SOLV/EDC & CMP PLANT NOTIFICATION OF PROCESS CHANGE CHECKLIST

Description and Location of Change (Scope): Add access deck for V-1540 filters.

V-1540 DECK

V-1540 Filter Deck

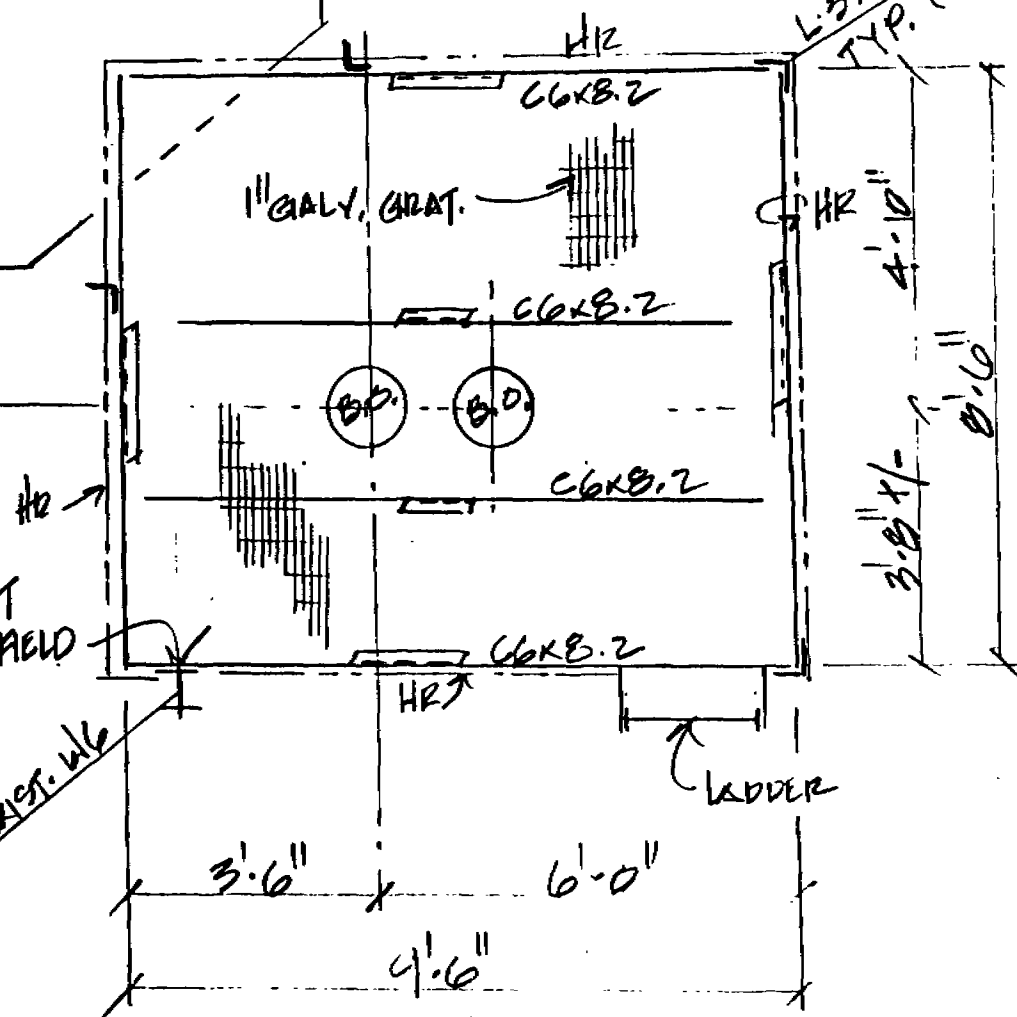
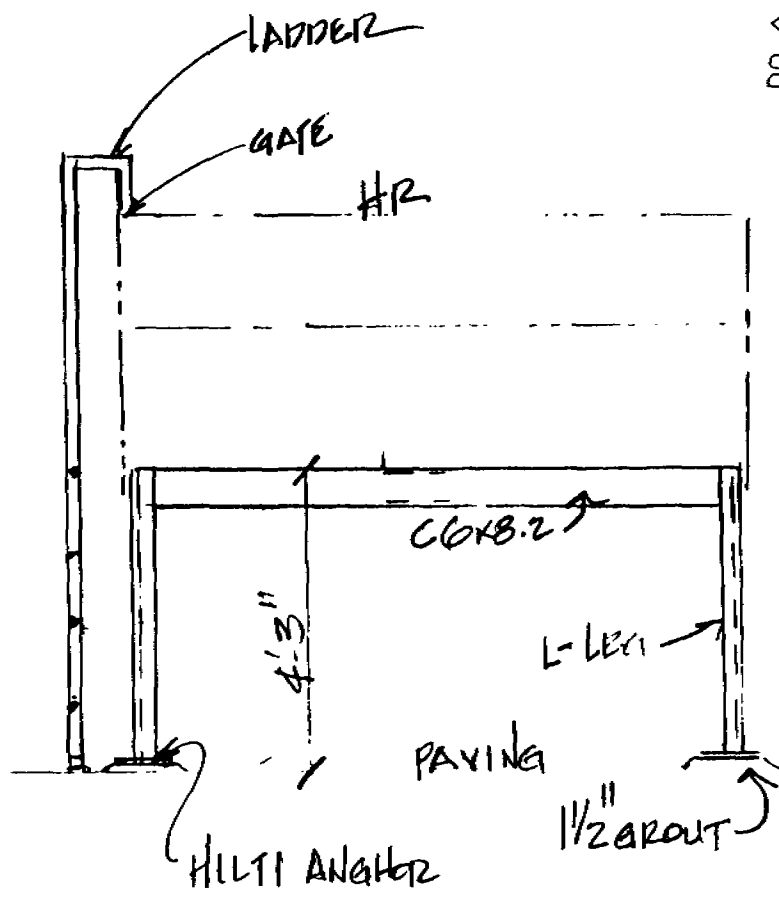
Technical Basis for Change: Permanent access to the filter is required for routine maint. & cleaning.
